UNITED STATES
DEPARTMENT OF THE INTERIOR
BUREAU OF LAND MANAGEMENT

SUNDRY NOTICES AND REPORTS ON WELLS
Do not use this form for proposals to drill or to re-enter an
abandoned well. Use form 3160-3 (APD) for such proposals.

8. Well Name and No.
BURCH KEELY UNIT 263

9. API Well No.
30-015-28336-00-S1

Burch Keely Unit 263

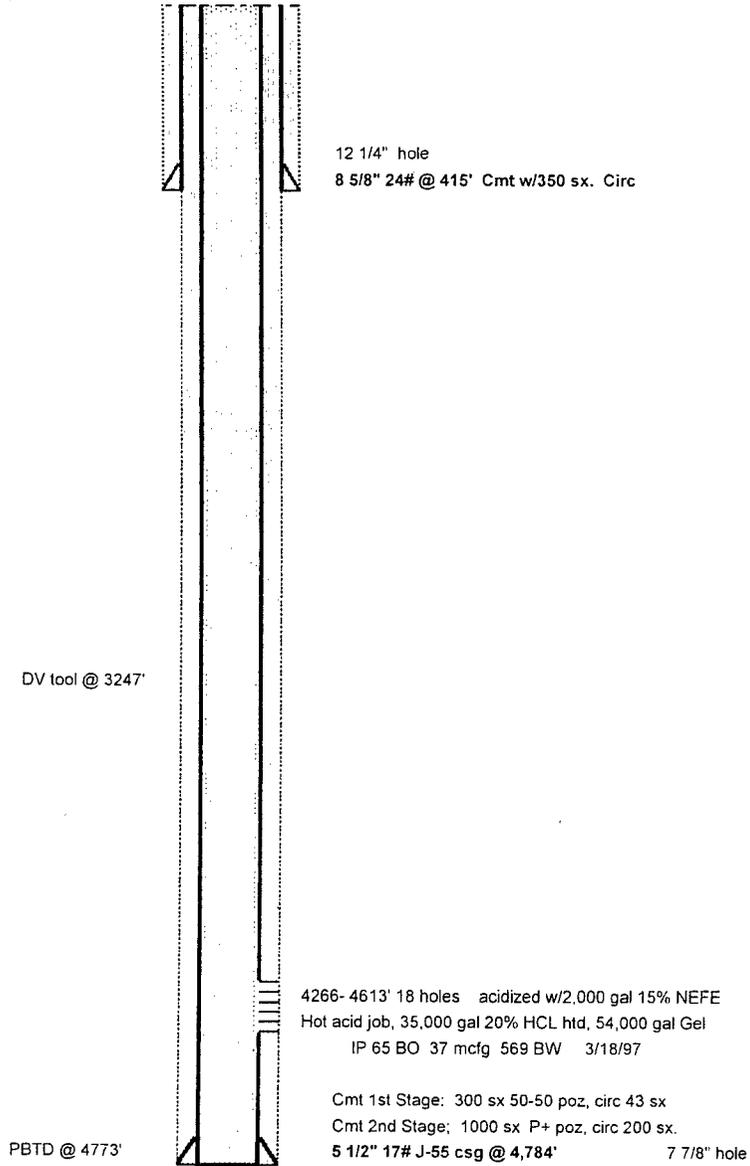
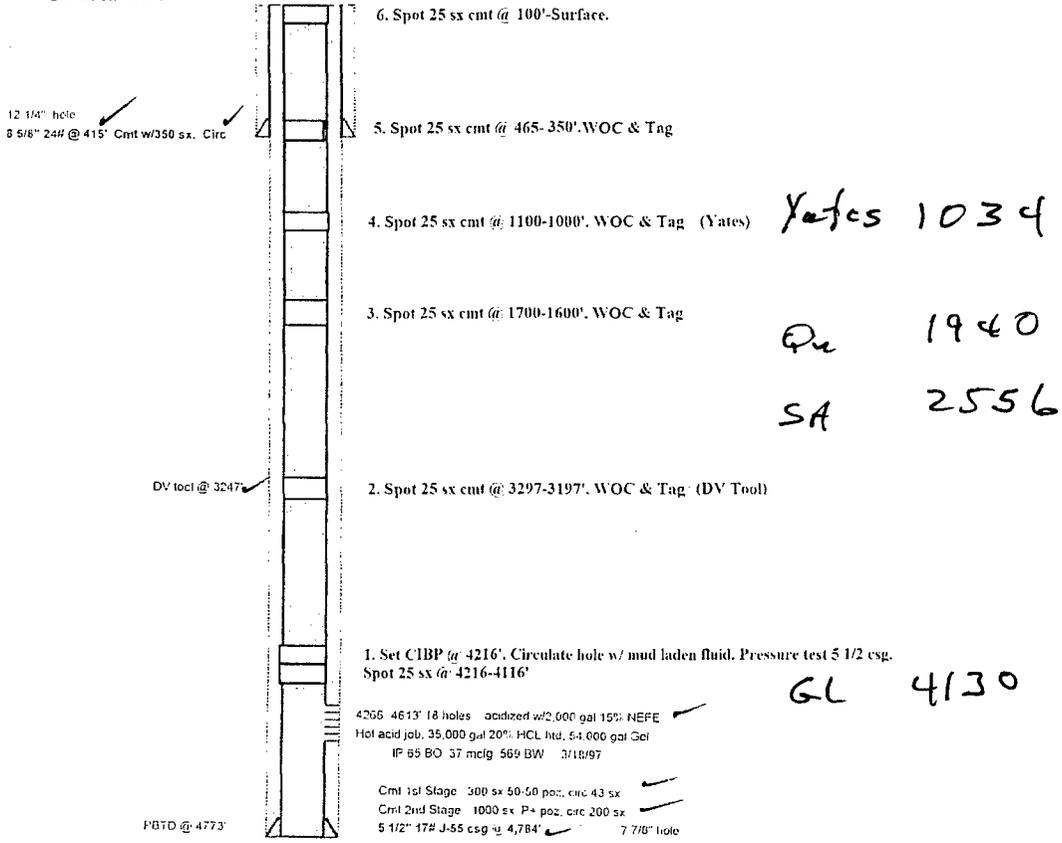
- Set CIBP @ 4216'. Circulate hole w/ mud laden fluid. Pressure test 5 1/2 csg. Spot 25 sx @ 4216-4446' 4080.
- Spot 25 sx cmt @ 3297-3197'. WOC & Tag (DV Tool). 130' minimum
- Spot 25 sx cmt @ 1700-1600'. WOC & Tag. 2621 - 2491.
- Spot 25 sx cmt @ 1100-1000'. WOC & Tag. (Yates) 1084 - 984
- Spot 25 sx cmt @ 465-350'. WOC & Tag.
- Spot 25 sx cmt @ 100-Surface.
- Cut off well head, weld on Dry Hole Marker.

Below ground level dry hole marker required

**** BLM REVISED ** BLM REVISED ** BLM REVISED ** BLM REVISED ** BLM REVISED ****
